THESE PLANS have been examined for compliance with the Ontario Building Code Requirements. A Building Permit is in Order to issue subject to any changes noted under the condition that the building will be constructed in accordance with the code

2070
CORNER LOT
GARDEN 11-065
ELEVATION 1
A1 PACKAGE
O.REG. 332/12

TITLE SHEET
BARLASSINA CONSTRUCTION
CITY OF CAMBRIDGE

FIRST FLOOR PLAN EL-1
BARLASSINA CONSTRUCTION
CITY OF CAMBRIDGE

REAR ELEVATION 1
BARLASSINA CONSTRUCTION
CITY OF CAMBRIDGE

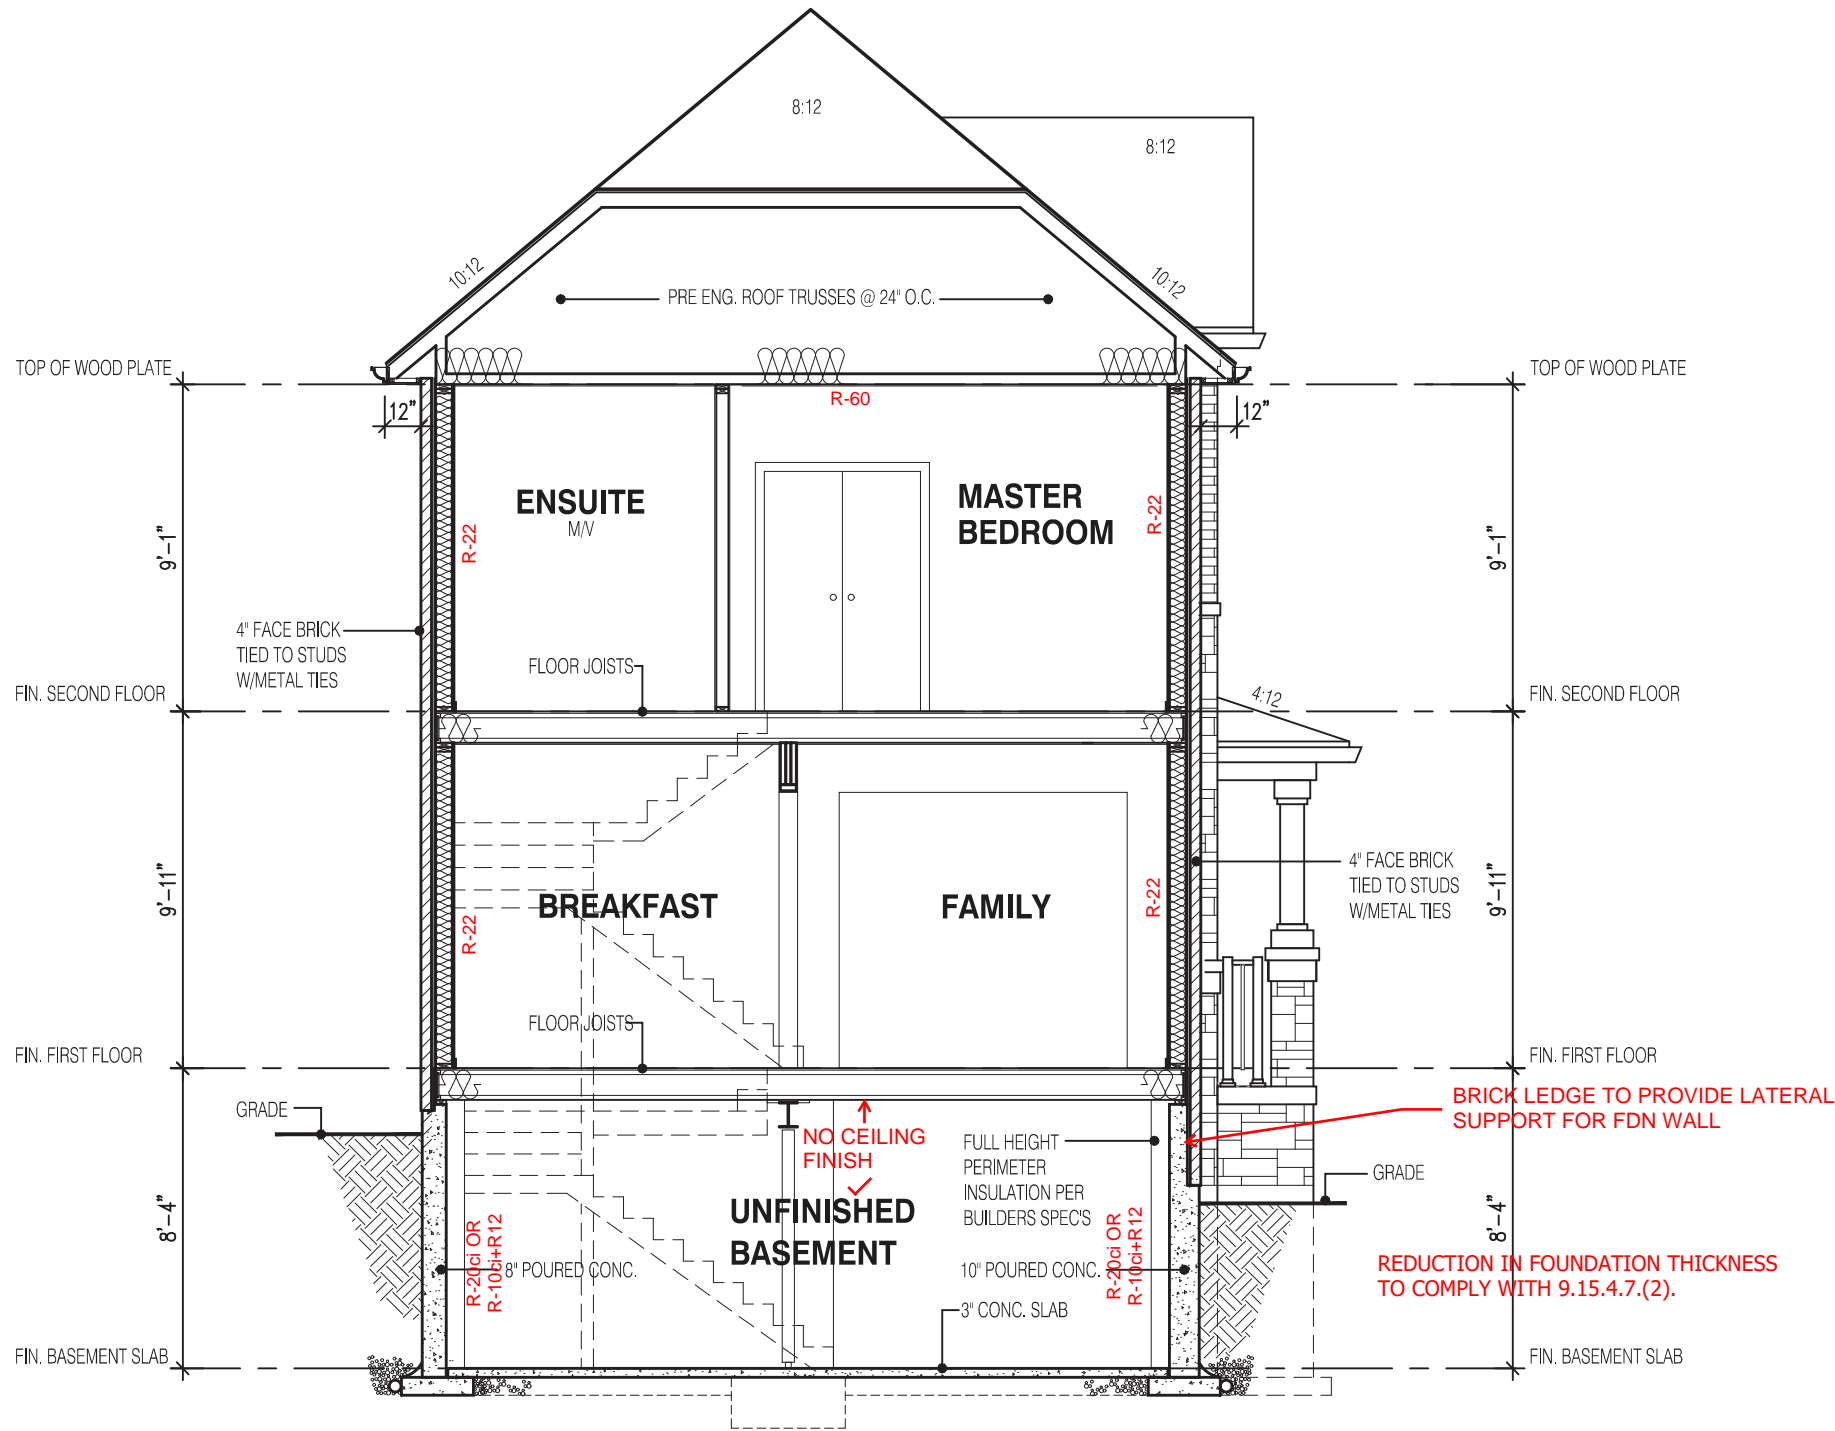
BRICK LEDGE TO PROVIDE LATERAL
SUPPORT FOR FDN WALL

REDUCTION IN FOUNDATION THICKNESS
TO COMPLY WITH 9.15.4.7.(2).

EXTERIOR CONCRETE STAIRS w/ MORE
THAN 2 RISERS TO MEET THE
REQUIREMENTS OF 9.8.9.2.(1)

A LIGHT IS REQUIRED AT ALL ENTRANCES
TO A SINGLE FAMILY DWELLING

ALL GUARDS TO COMPLY WITH SB-7 OR P.ENG DESIGN.
GUARDS TO BE MIN. 36" HIGH (900mm). WHERE DECK
WALKING SURFACE TO FIN. GRADE EXCEEDS 5'-11"
(1.8m), GUARD HEIGHT TO BE 42" HIGH (1.2m)

ENSURE P.ENG STAMPED RAILING
DOCUMENTATION AND ATTACHMENT DETAILS
ARE AVAILABLE FOR REVIEW BY THE INSPECTOR
